[Docket No. FAA–2015–7527; Directorate Identifier 2015–NM–094–AD; Amendment 39–18686; AD 2016–21–05]

**Airworthiness Directives; The Boeing Company Airplanes**

**ACTION:** Final rule.

**2016–21–05 The Boeing Company:**  
Amendment 39–18686; Docket No. FAA–2015–7527; Directorate Identifier 2015–NM–094–AD.

**Figure 1 to paragraph (h) of this AD: Wiring Installation - Right Engine Fuel Spar Valve**

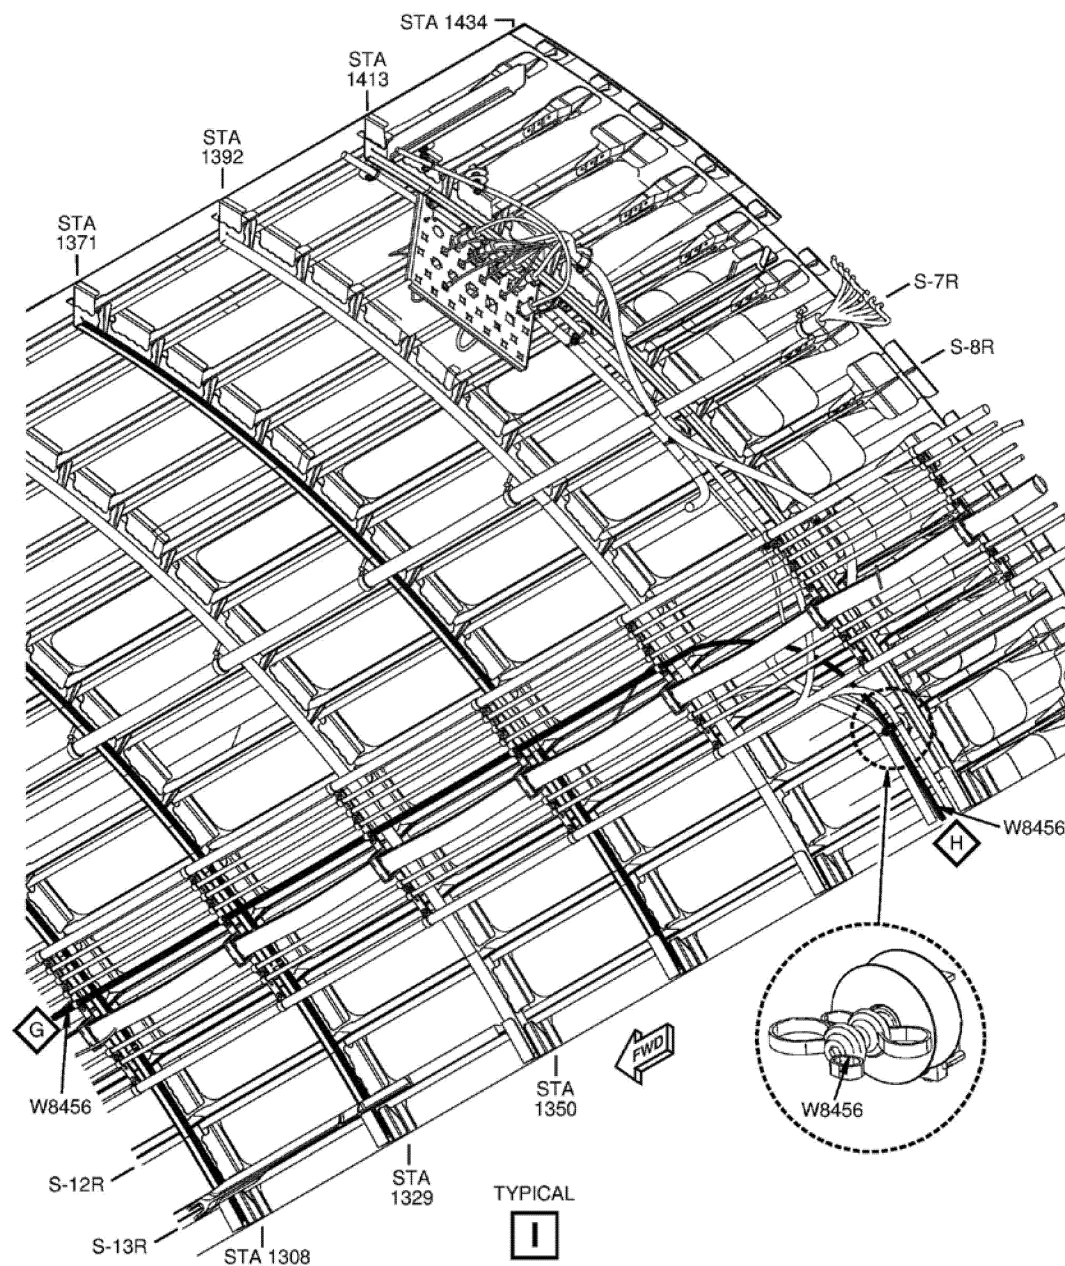
appropriate source of service information in this AD because it is not an FAA-approved document. However, we acknowledge that for certain airplanes, Figure 22, Sheet 9, of Boeing Special Attention Service Bulletin 777–28–0061, Revision 2, dated May 4, 2015, includes an editorial error, which shows incorrect wire routing. Boeing Service Bulletin Information Notice 777–28–0061, IN 03, dated November 16, 2015, allows for a modification of Group 2 airplanes that meets the requirements of the AD without an additional burden to operators. We have included a corrected figure in paragraph (h) of this AD to address this issue.

(1) Where Boeing Special Attention Service Bulletin 777–28–0061, Revision 2, dated May 4, 2015, specifies to use Figure 22, Sheet 9, for the wiring installation of the right engine fuel spar valve, this AD requires using figure 1 to paragraph (h) of this AD.
